Richmond Bridge and Approaches- Intersection upgrade at March Street and Bosworth Street, Richmond

Addendum review of environmental factors
3 - Vegetation and tree removal and
property adjustments

Transport for NSW | May 2020

Prepared by DM Roads and Transport for NSW

Figure 1-2: The proposed modification

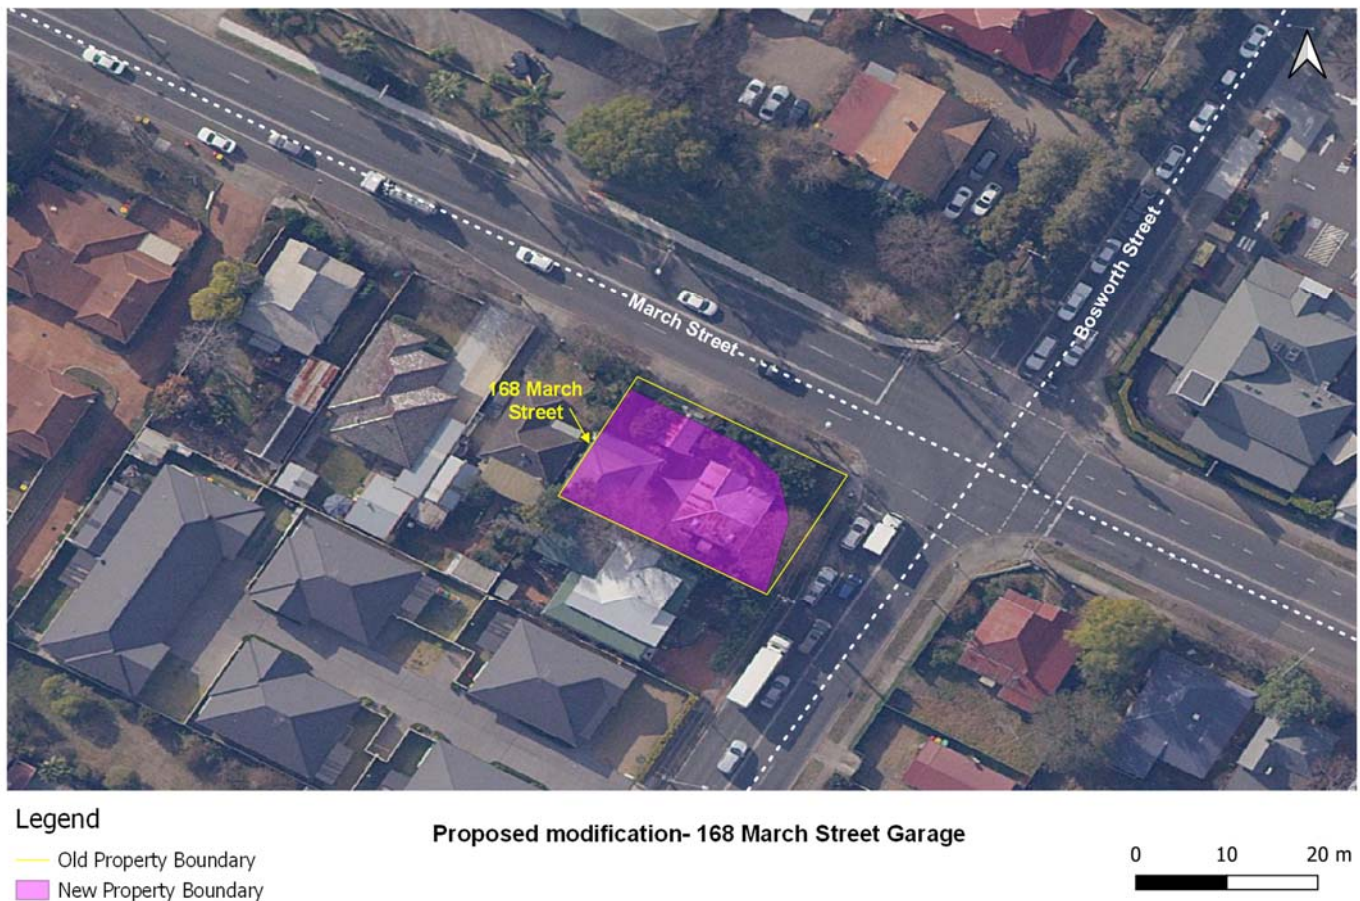
Transport for NSW proposes to modify the Richmond Bridge Approaches- Intersection of Bosworth Street and March Street (the Project) by the removal additional thirty (30) street trees along March Street, the removal vegetation in the Transport for NSW owned lot (1/DP518997) at the north-west corner of March Street and Bosworth Street intersection and demolishing and rebuilding of the garage at 168 March Street to allow for road-way widening, the adjustment of utilities and construction of the kerbing and footpath. Key features of the proposed modification would include:

The location of the proposed modification is shown in **Figure 1-1** and the proposed modification is shown in **Figure 1-2**. Chapter 3 describes the proposed modification in more detail.

Figure 3-1: Key features of the proposed modification

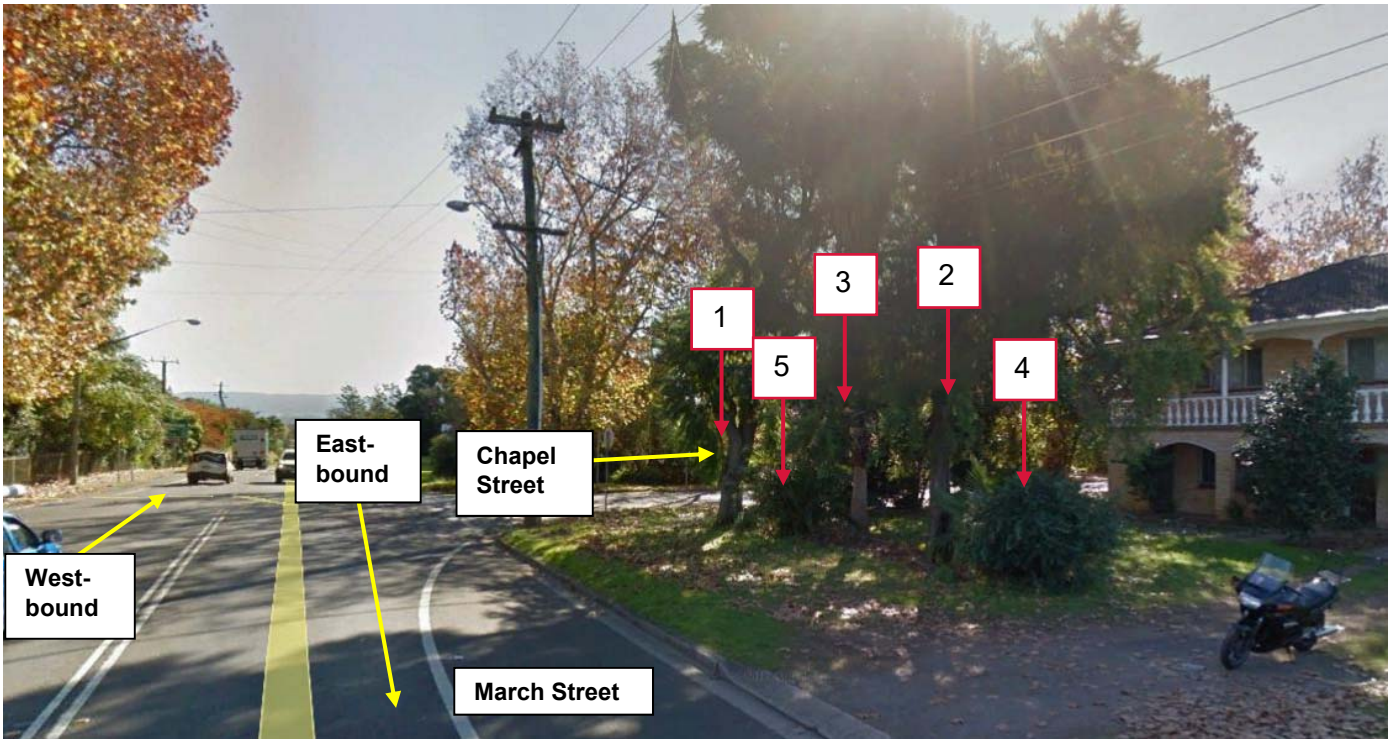
Transport for NSW proposes to modify the *Richmond Bridge Approaches- Intersection upgrade at Bosworth Street and March Street, Richmond* to remove thirty street trees and demolishing and rebuilding a garage along March Street to allow for the widening of the road corridor and the relocation and adjustment of utilities, kerbing and footpath. The proposed modification is shown in Figure 1-2 and Figure 3-1.

- The removal of an additional 30 street trees along March Street
- The removal of vegetation in the corridor, particularly in the Transport for NSW owned lot (1/DP518997) at the north-west corner of March Street and Bosworth Street
- The demolition and like-for-like re-building of a garage at 168 March Street.
